COPPERSTRING EIS

Attachment F - Vegetation Clearing Works plans

Flinders Substation to Dajarra Road Substation

KP 447WD
FLR-DJR-190

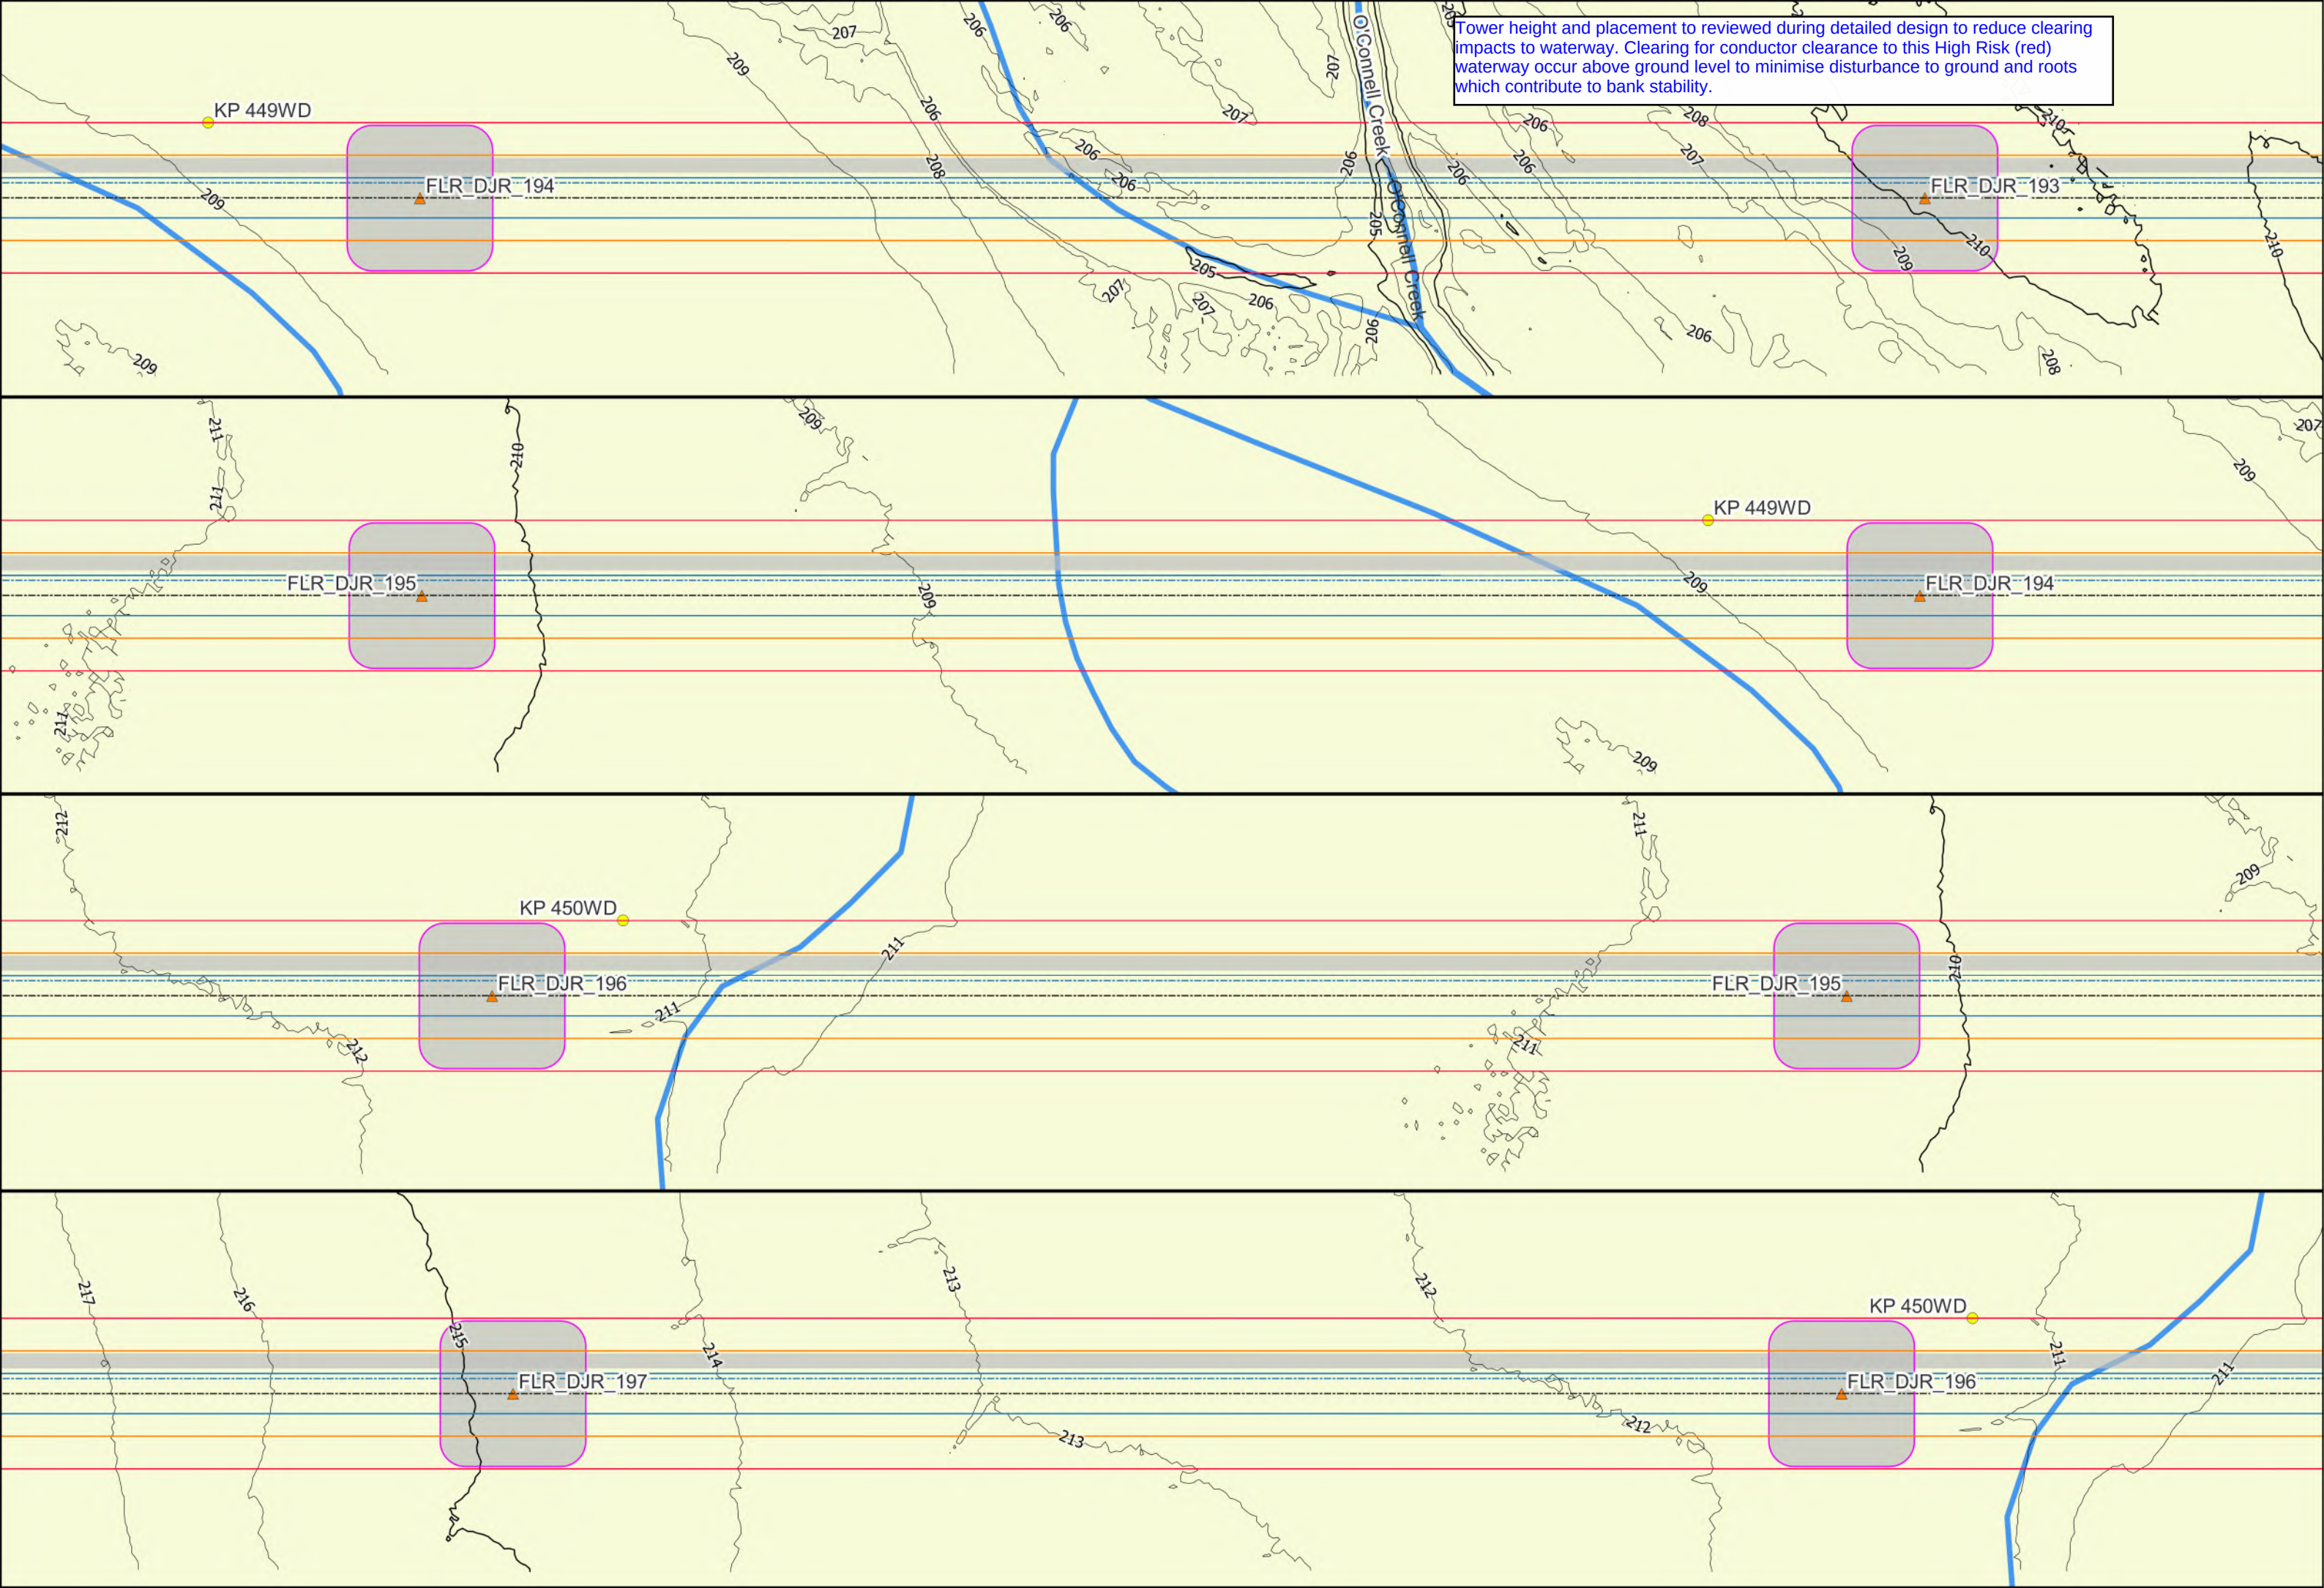
Tower assembly area to be reconfigured to not be within 15m of the high bank of waterway and to avoid clearing near or within the bed and banks for the waterway.

O'Connell Creek
O'Connell Creek

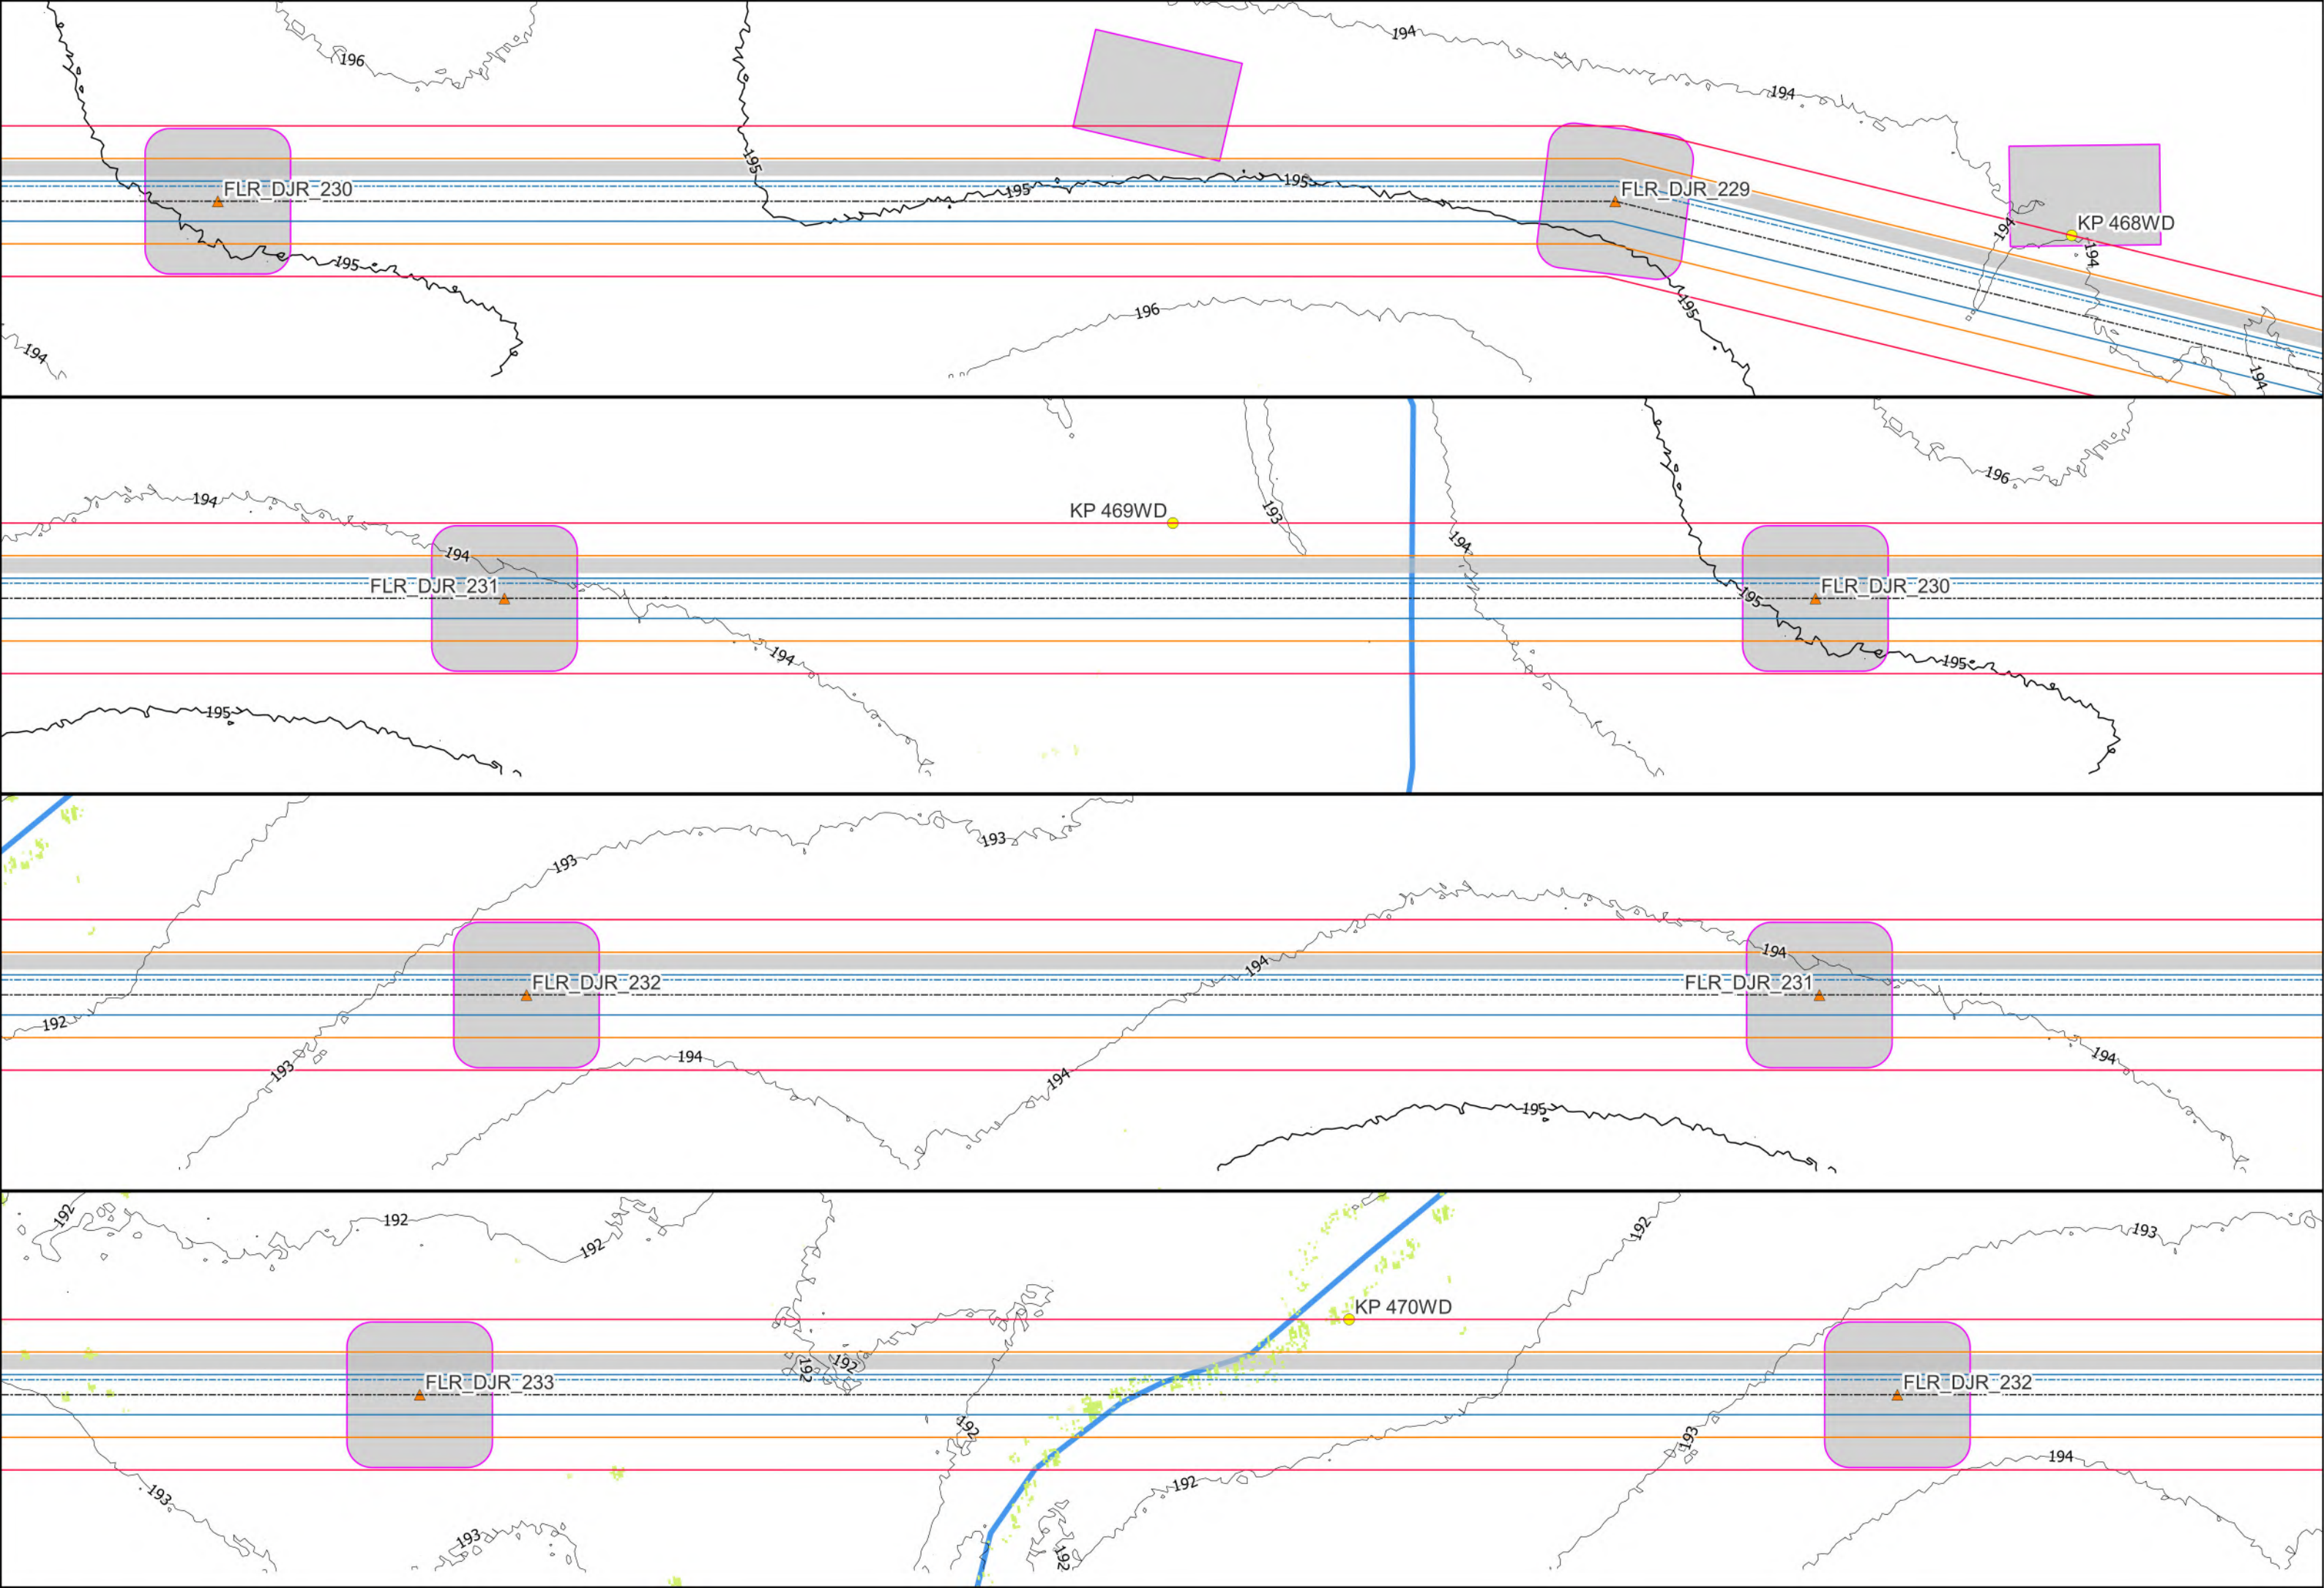
Position of Brake and winch to be reviewed during detailed design to be relocated away from daf waterway.

FLR DJR 258

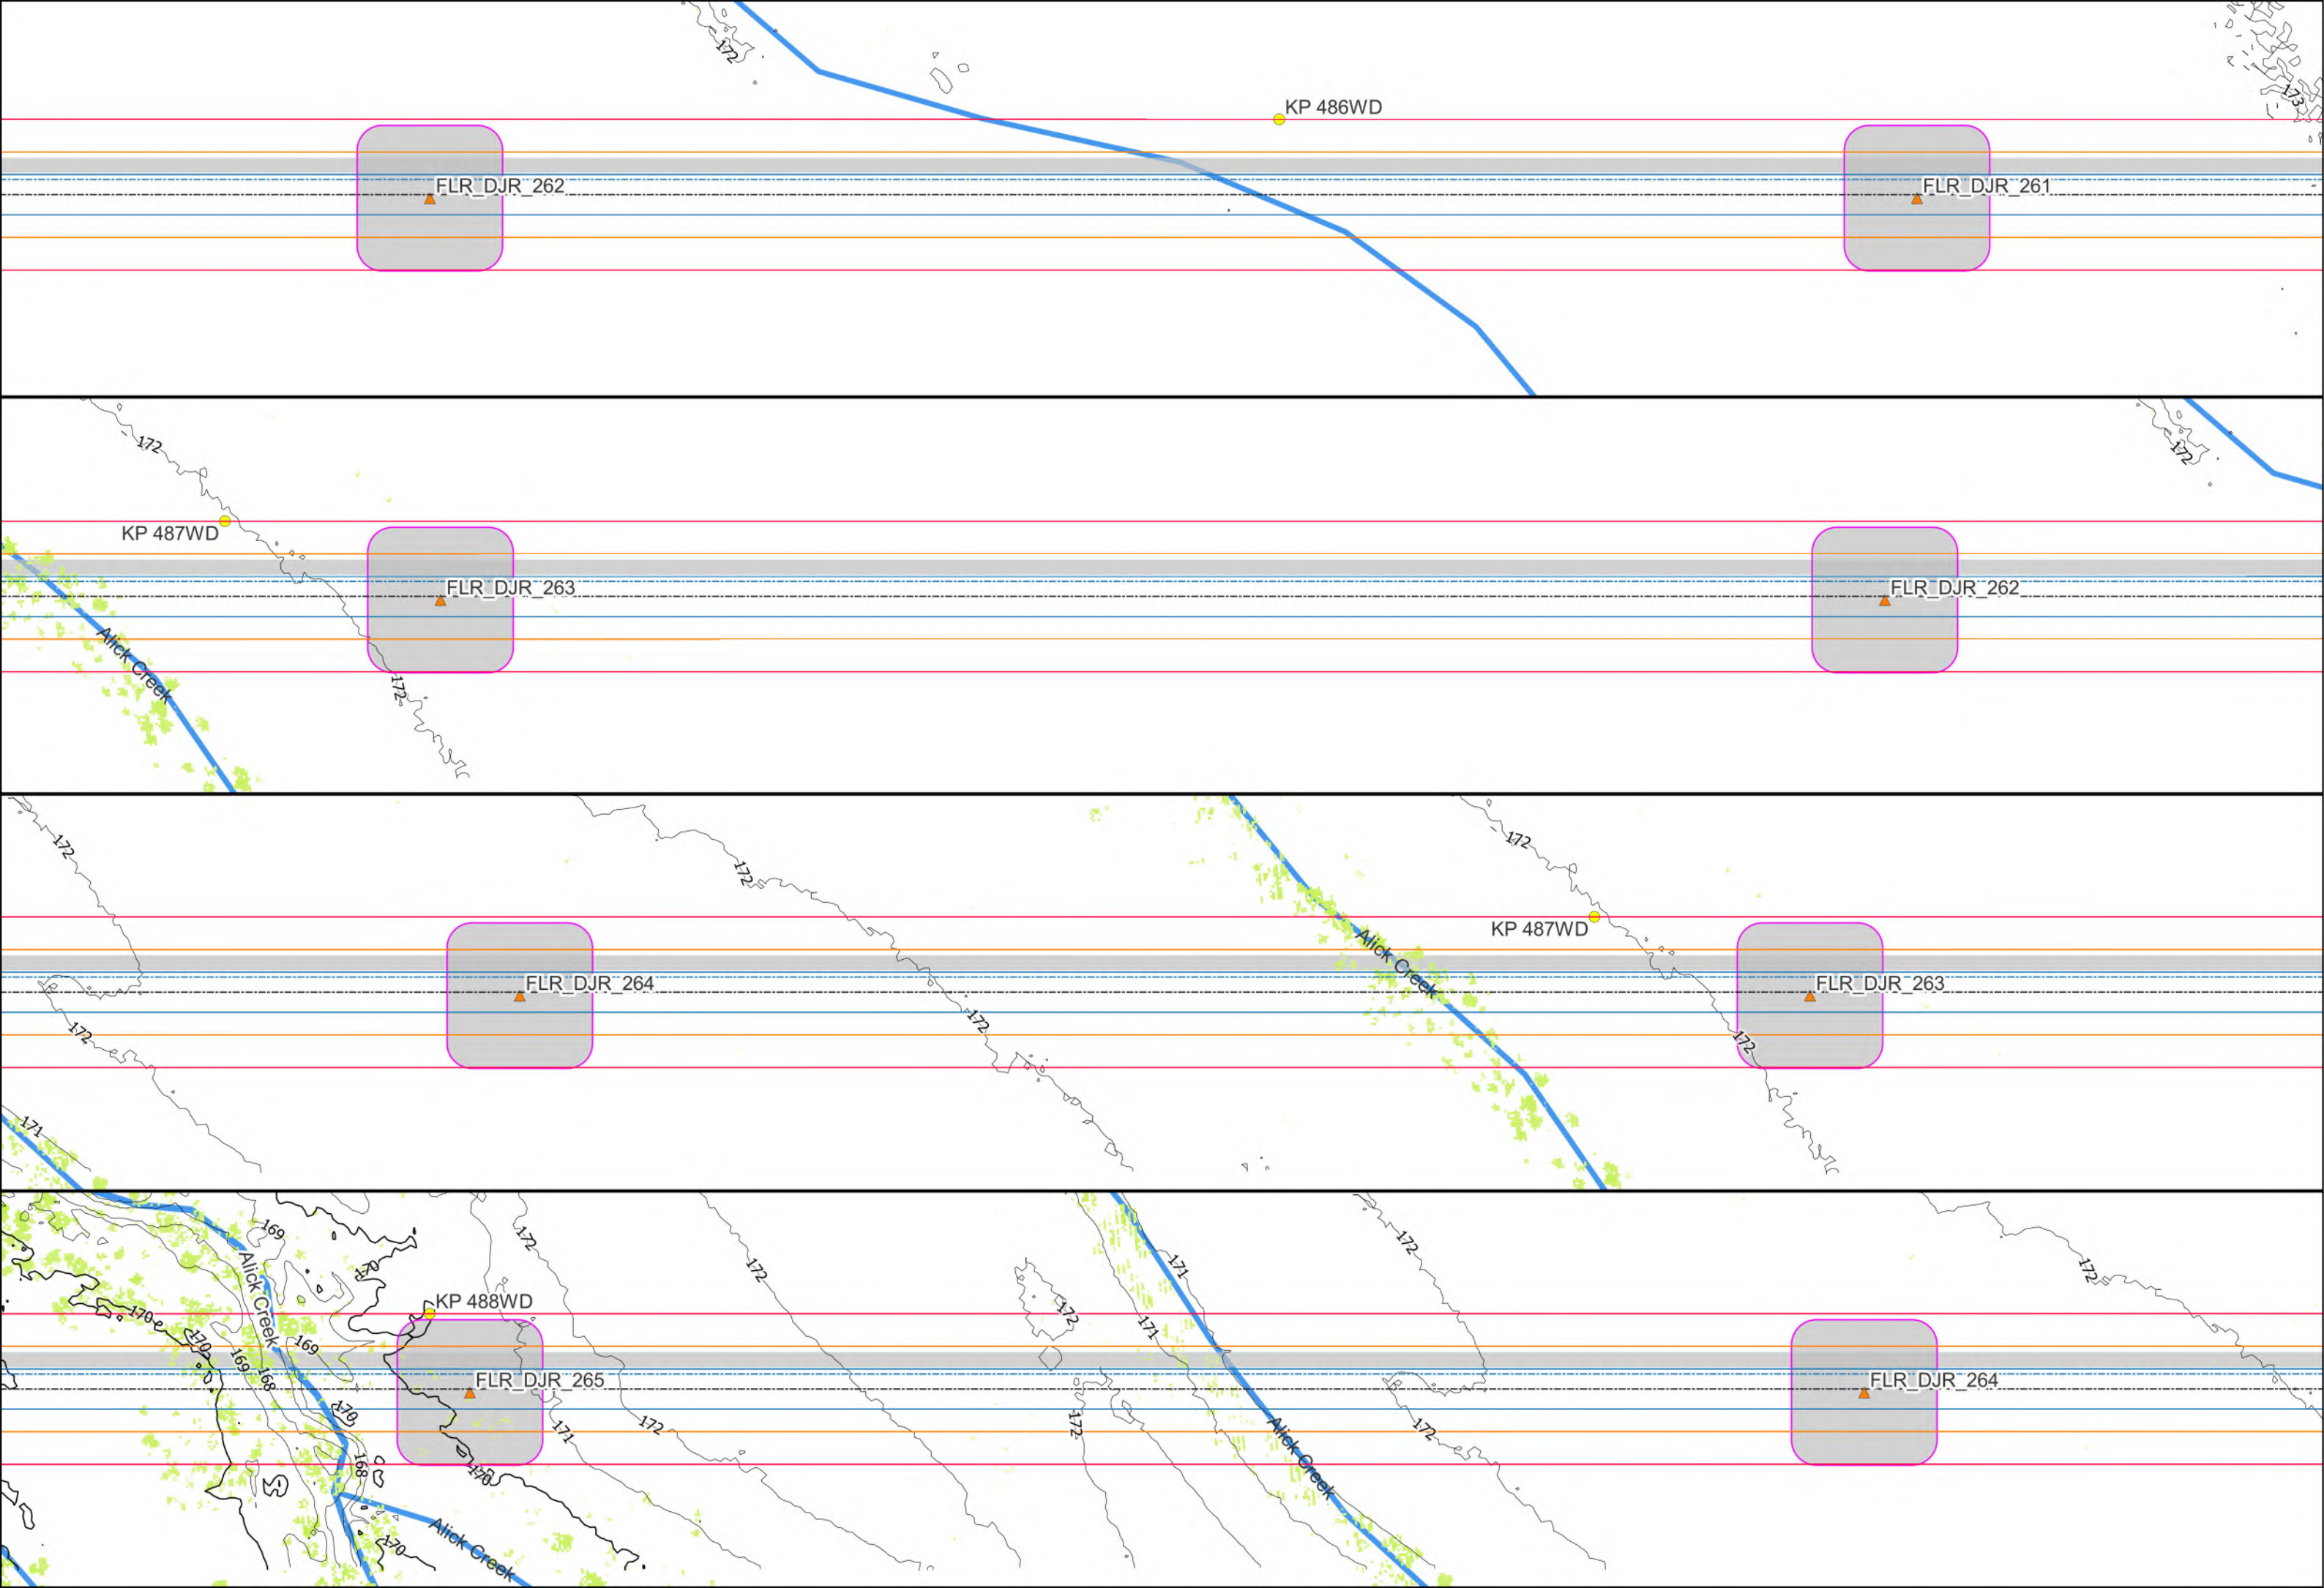
Tower assembly area to be reconfigured to not be within 15m of the high bank of waterway and to avoid clearing near or within the bed and banks for the waterway.
